SUBJECT: M2013-031 New Hay Camp Pit, McStone Aggregates Commitment

This letter memorializes the e-mail correspondence (see references, below) regarding the adequacy review.

# MAP S-1 Manmade Structures

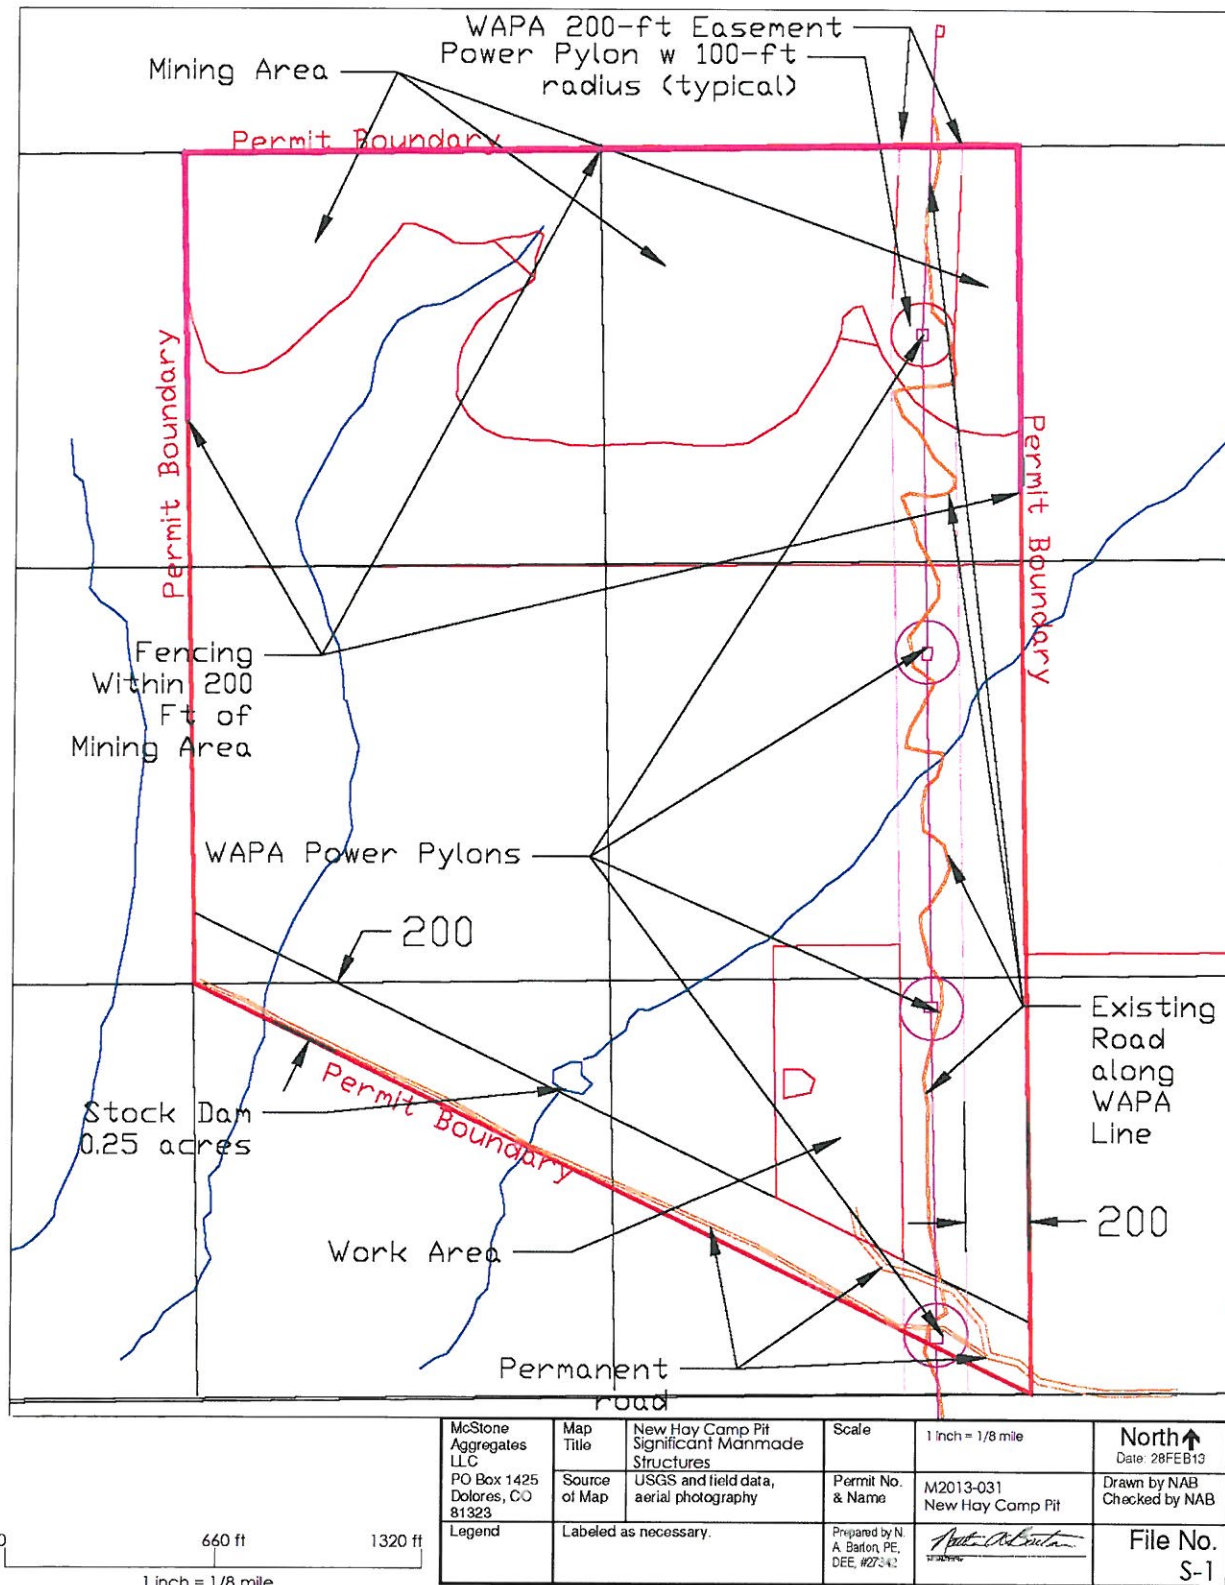
I found that the title block on maps C-1, C-2, F-1, F-2, and S-1 have some confusing information. Please find attached maps which have that information corrected, and which have a graphical scale added and some more marginal information. The maps as originally submitted are drawn with a scale of 1"=660', as required, but the marginal info was confusing. I apologize for that. Please let me know if this clarifies matters. I believe that all of those maps (and other maps) have legends, title, date, north arrow, scale, and other required information. Please let me know if I have overlooked that on any of the maps. Some of the maps in various exhibits are showing a larger area beyond the permit area, and therefore area a different scale.

Attachments (sent separately): Corrected maps. C-1, C-2, F-1, F-2, and S-1

**MAP F-1: Entire site showing phases of reclamation**

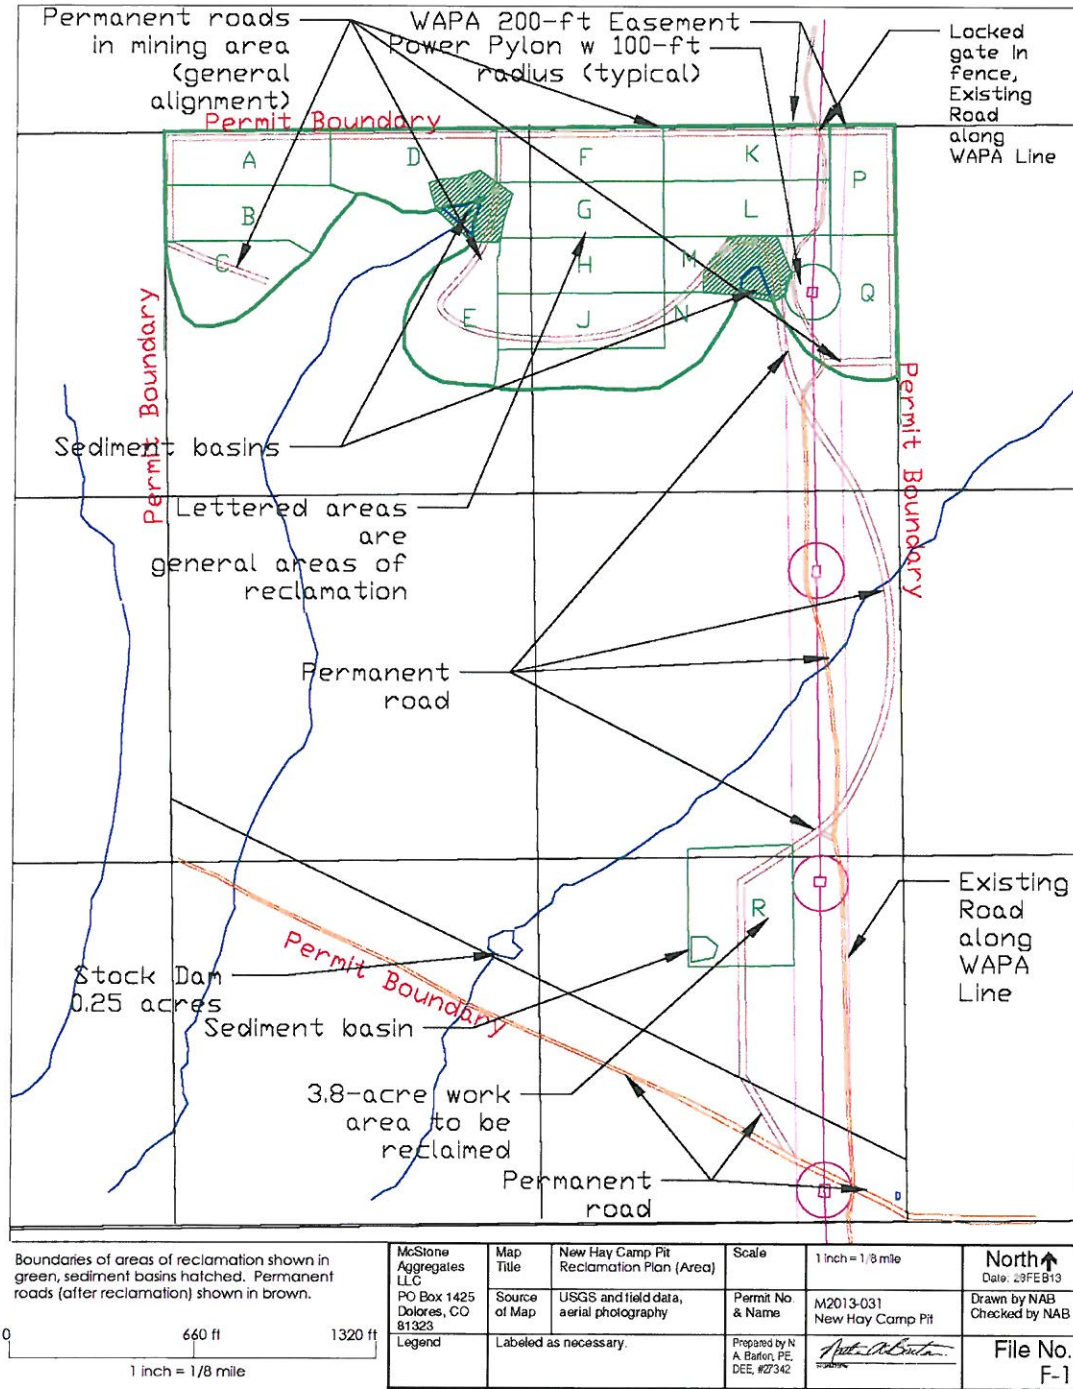
**Acreage needing reclamation at any one time:** The maps are not intended to indicate that as much as 22.5 acres of disturbed, unreclaimed land will exist at some given time (any one time); the correct number as stated in Exhibit L is 11.9 acres (worst case, year 3-4). The first table in Exhibit L shows the reclamation by task AND area: the bottom line is not a sum or total. 22.5 is the total disturbed land within the mining area which is not on the perimeter (that is, not requiring work to slope and grade the highwalls).
